PERMIT

SEWAGE DISPOSAL SYSTEM

SUBDIVISION Waterford Farm - Tenant House ROAD Jennings Chapel Rd LOT _____

PERCOLATION TESTING

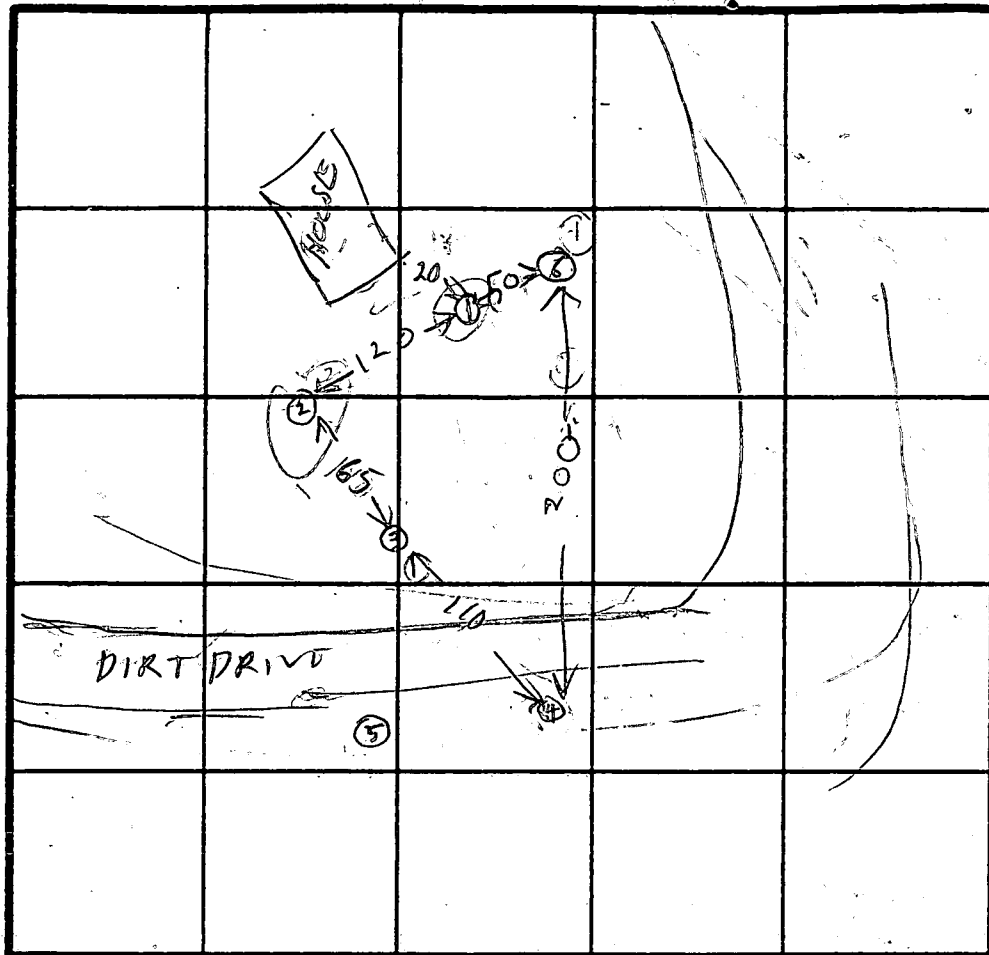
REASONS FOR REJECTION OR HOLDING * CUNDORY INSP OF EXISTING SEPTICS + WELL REQ'D.

EXCAVATE AS NECESSARY IF PROBLEMS OBSERVED. OWNER WANTS TO USE WELL IN REMAIN.

3/29/88 EXISTING HOUSE OK SUBMITT CERTIFIED
HOLE LAY BACK OK FOR + BURN

CERTIFIED TEST HOLE LOCATIONS.

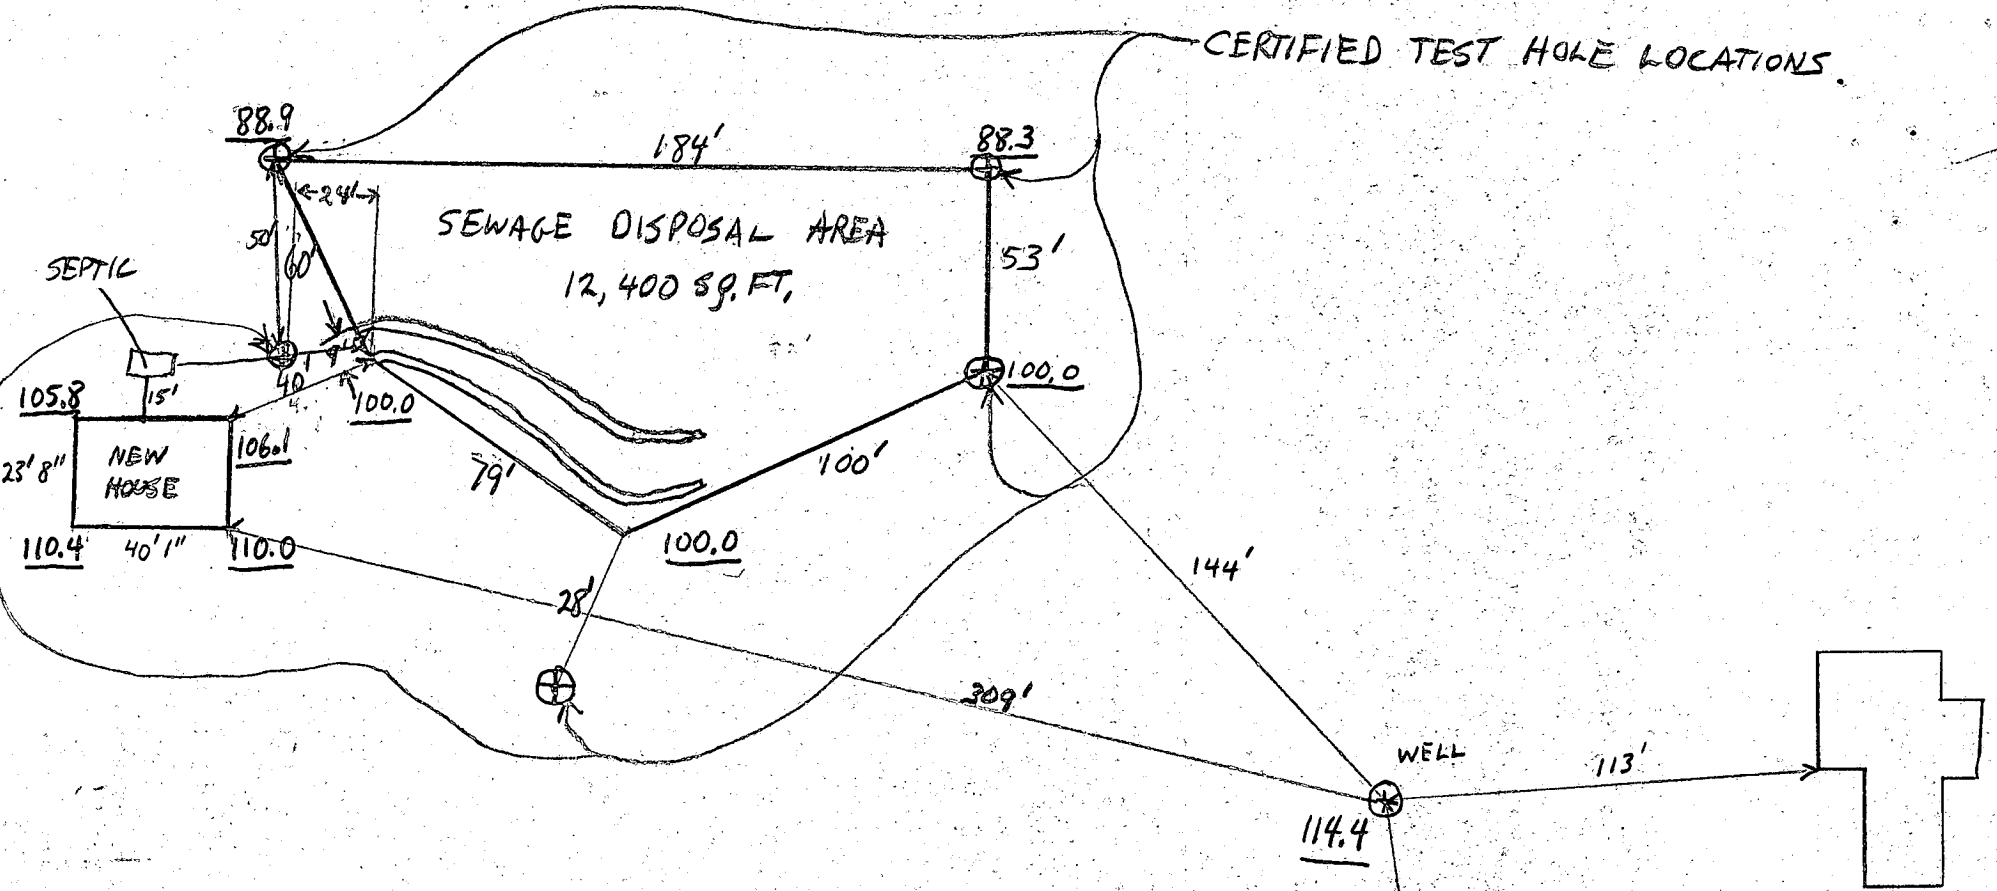
6/6/88
elevation
OK
SAC
